SCR Back Pressure Sensor Modification

**GTH1056 models with a SCR
back pressure sensor.**

TECH-TIP

Step 3

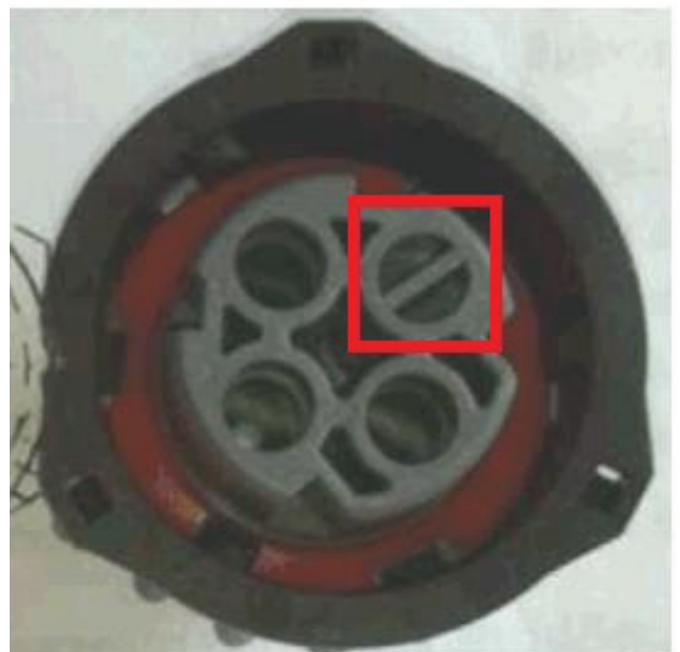
Looking at the connector, you may have a bar across the blank wire passage, this bar must be completely removed.

Step 3

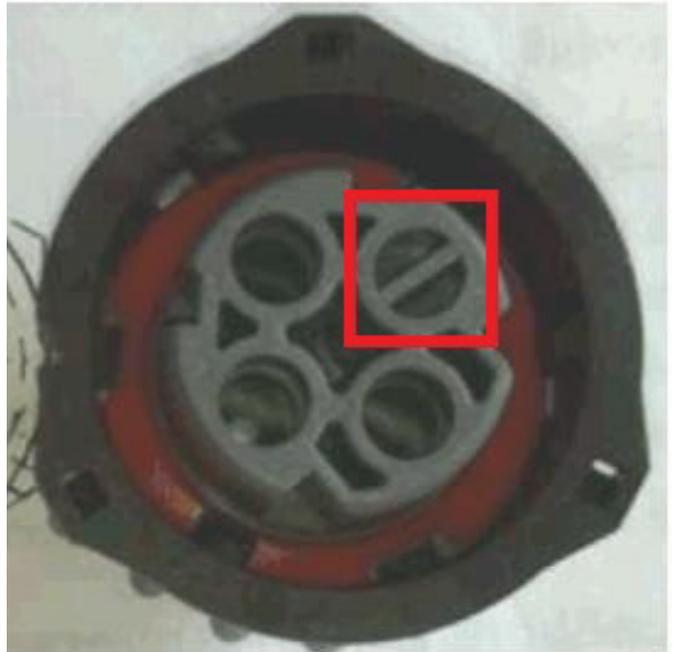
Using an 1/8" drill bit, create an air passage in the center of the plug blocking the empty wire passage. This will allow the sensor to monitor atmospheric air pressure.
